Riverline Park Splash Pad

Permit Set Drawings

Exhibit G
Assumptions and Clarifications
City of Smyrna River Line Park Splash Pad
05/08/2024

Marked up drawings provided by the City of Smyrna

A-101

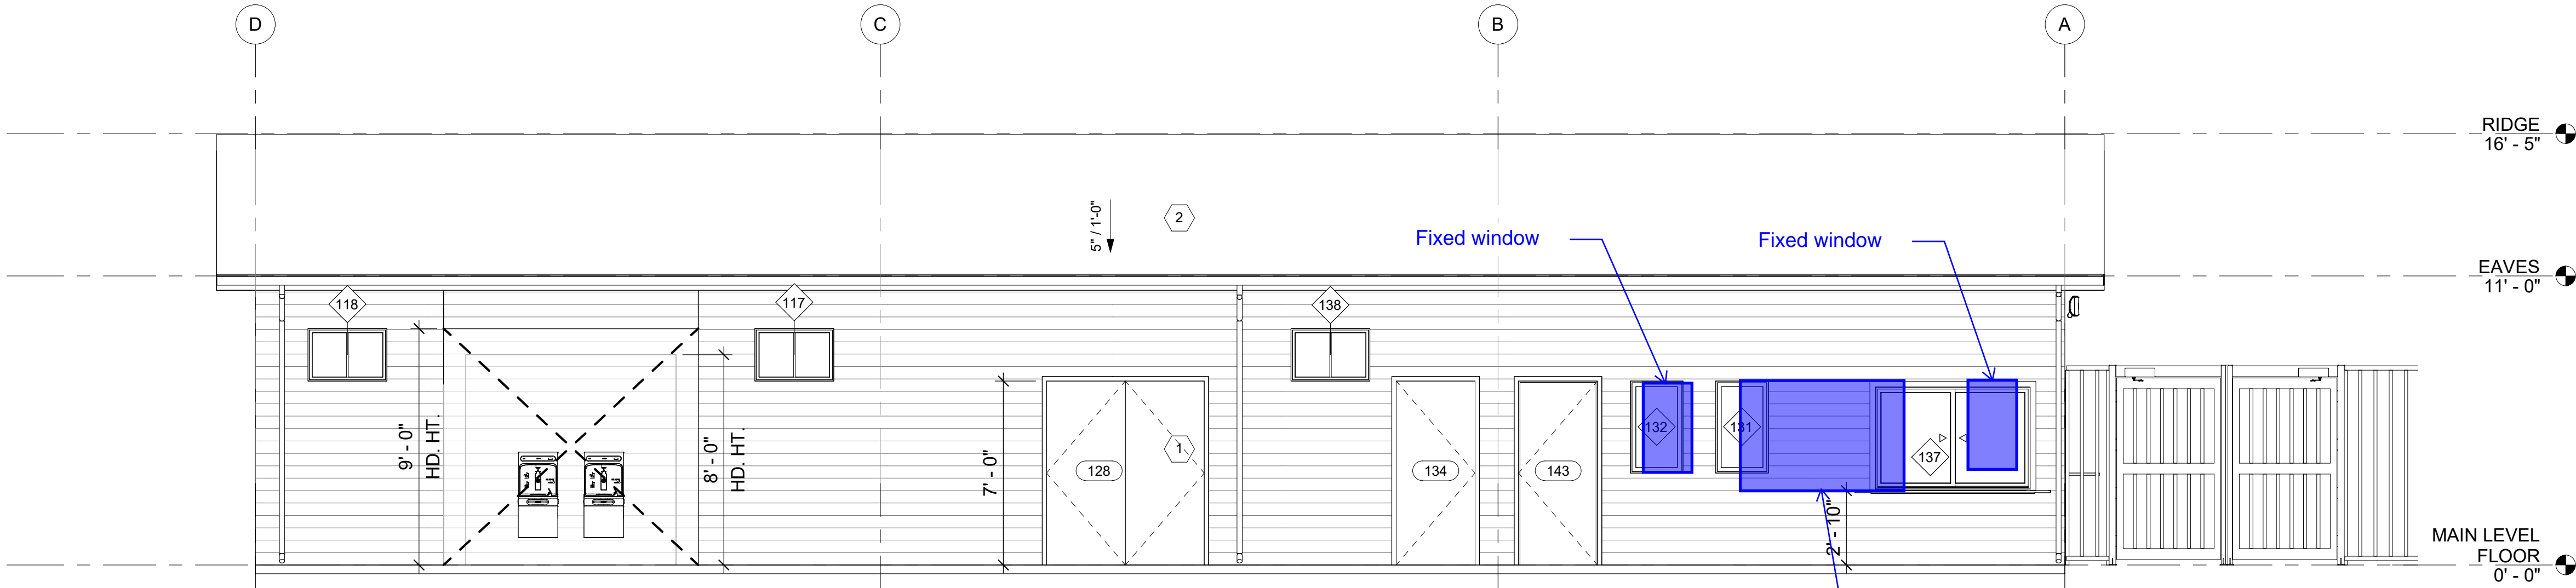
1. Inclusions:
 - a. Solid surface countertops with bullnose edges and eased backsplashes at Men's/Women's Restrooms.
 - b. Stainless steel window counters at Windows 135 and 137 only.
 - c. Wall framing changes as shown in attached marked up drawings (Attachment 1; 2 pages).
2. Exclusions:
 - a. Stainless steel window counter at Window 136 is excluded per previous direction from City.
 - b. Freestanding stainless-steel tables are not included and assumed by City as part of the FF&E package.

1. Inclusions:
 - a. Alternate to convert IT Room to an IT closet by shifting wall between Storage Room and IT Room to the east and reduce size of IT Room. Change includes changing Door #130 to a double door all for the price of \$3,004.
 - b. Windows 130 and 132 are included as tempered windows although not indicated.
 - c. Window 136 is included as Window Type W01 in lieu of Type W04 per previous City discussions.
 - d. Door and window changes as shown in attached marked up drawings (Attachment 1; 2 pages).
 - e. Window 135 to be furnished as a single-hung window with stops.
 - f. Overhead security shutters to be added to Windows 130 thru 137 only.

- a. Shut off valve(s) to building for winterization.
- b. One (1) outdoor shower is included.
- c. Plumbing changes including addition of drain in Pump Room, relocating water and drain lines for ice machine, addition of mop sink, and addition of undersink grease trap as shown in attached marked up drawings (Attachment 1; 2 pages).

A-201

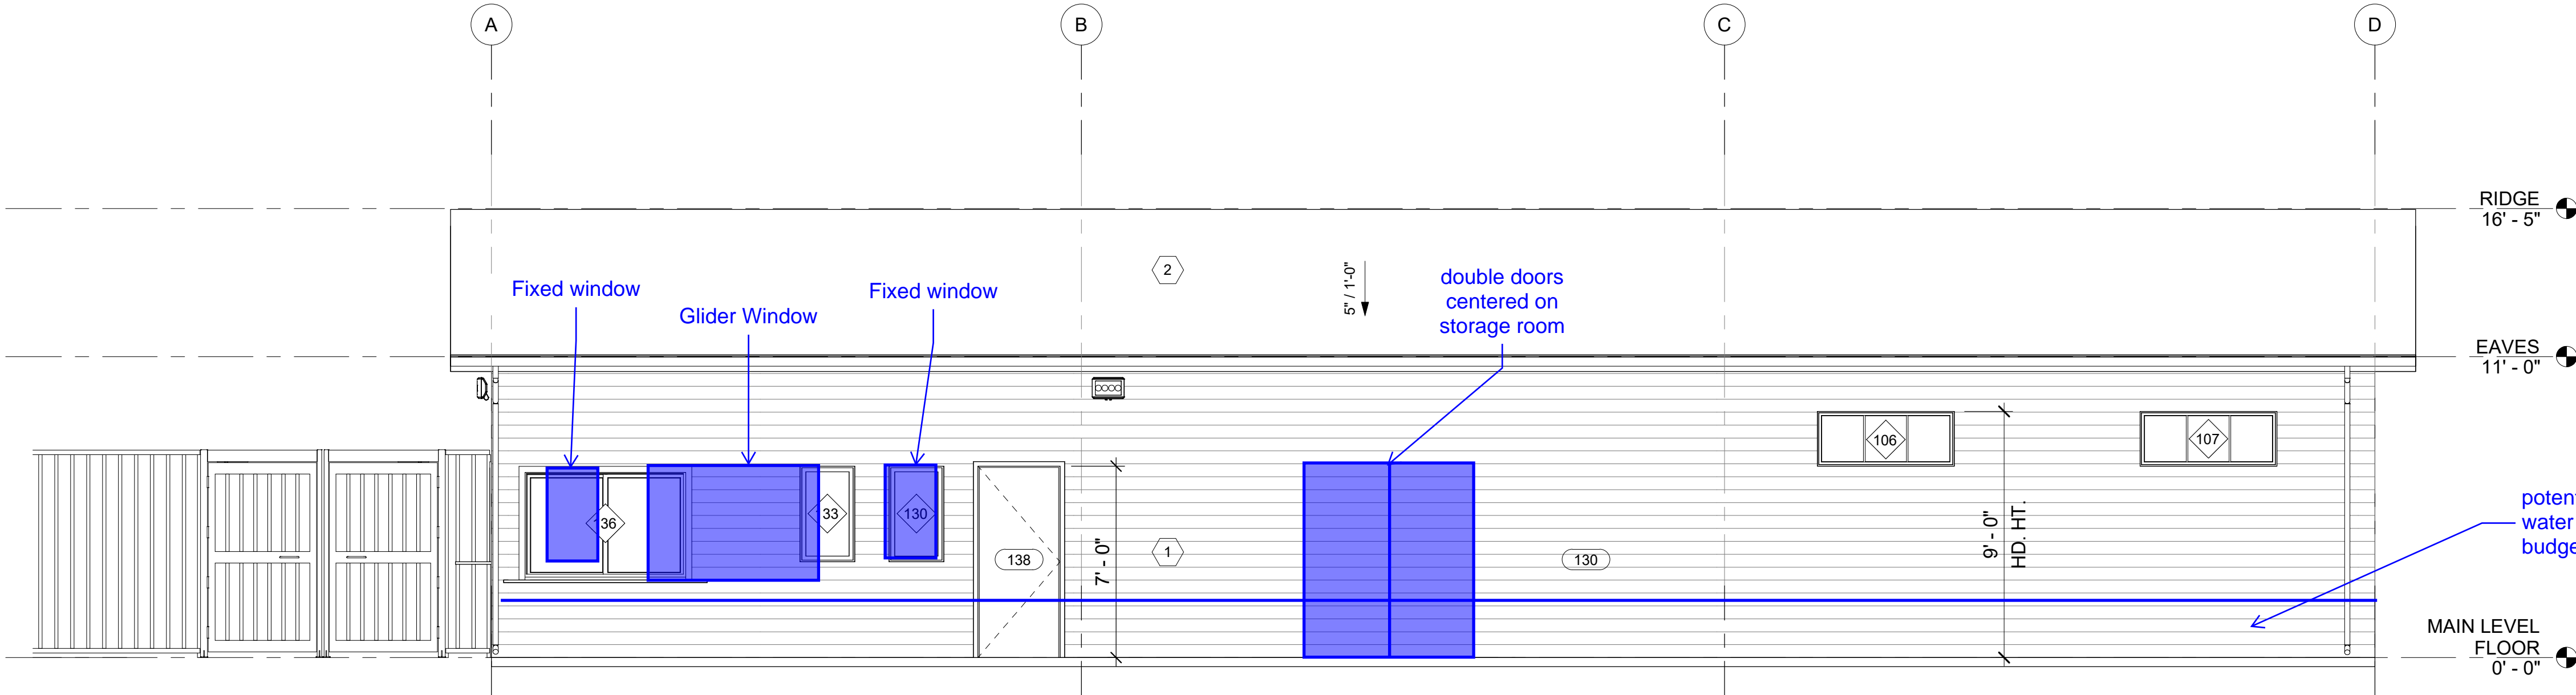
1. Inclusions:
 - a. 2' stone water table per City of Smyrna request. To match previous design intent as shown in 11/03/2023 drawings.
2. Exclusions:
 - a. Foundation drainage beneath building slab (interior side of footings).

- a. Site fencing as shown in Details 5 thru 7 / C-501 and not as shown on A-201.
- b. Decorative concrete scoring as shown. A deductive alternate to remove the 3x3 scoring per CS101, note 26 is provided in the amount of \$1,501.
- c. Design, furnish, and installation of modular block retaining wall.
- d. Permanent irrigation of planting beds is included although Watering/Irrigation Note 3 found on Sheet L-001 indicates permanent irrigation is not to be included.
